SCHMIDT PARCEL

EL PASO COUNTY

PLANNED UNIT DEVELOPMENT PLAN & PRELIMINARY PLAN

PRELIMINARY UTILITY & PUBLIC FACILITY PLAN

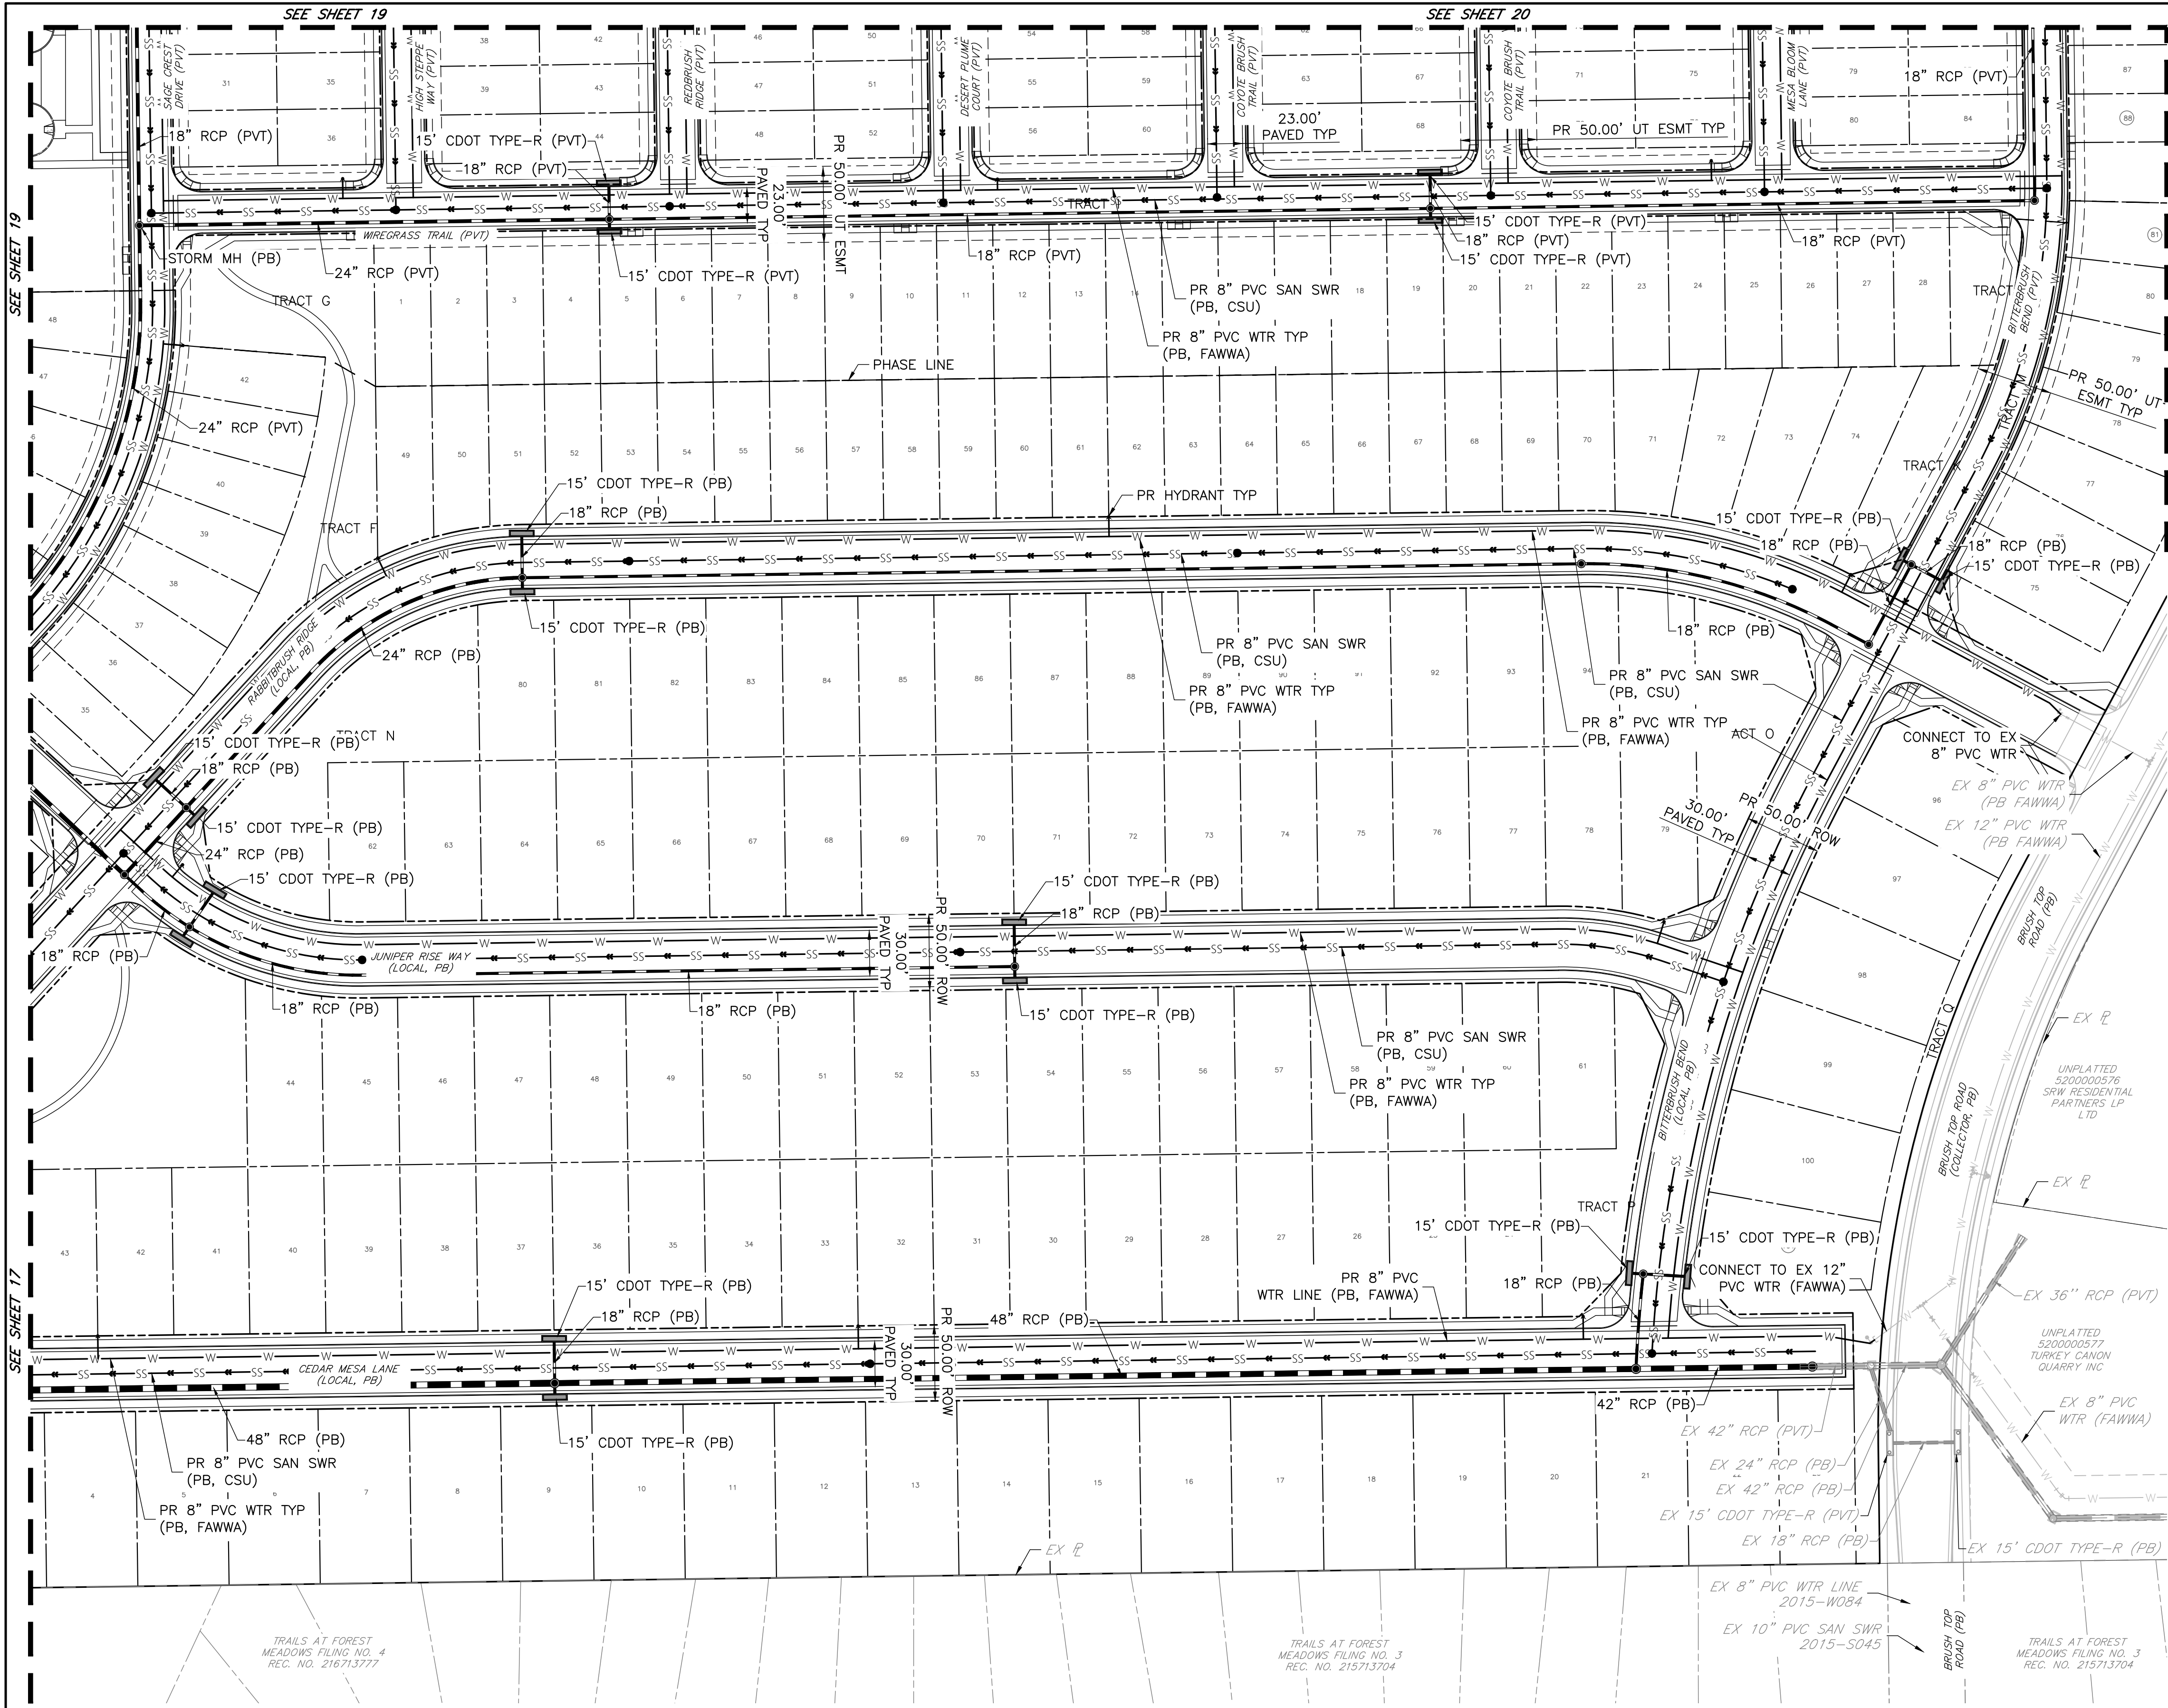
Show exact location and label a Springs Utilities wastewater metering design, associated equipment, and connections to CSU existing system.

Add note of electric service provider for electric equipment required for flume.

Add note: Gas service line must have minimum 6-foot horizontal separation when installed parallel to other utilities and structures.

Add note " Gas meters must be a minimum of 3-feet from doors, operable windows, or any vents or openings in walls."

Add note "CSU Field Engineer to determine final gas meter and service line locations. Contact Field Engineering at 719-668-4985 (Gas) with any questions."
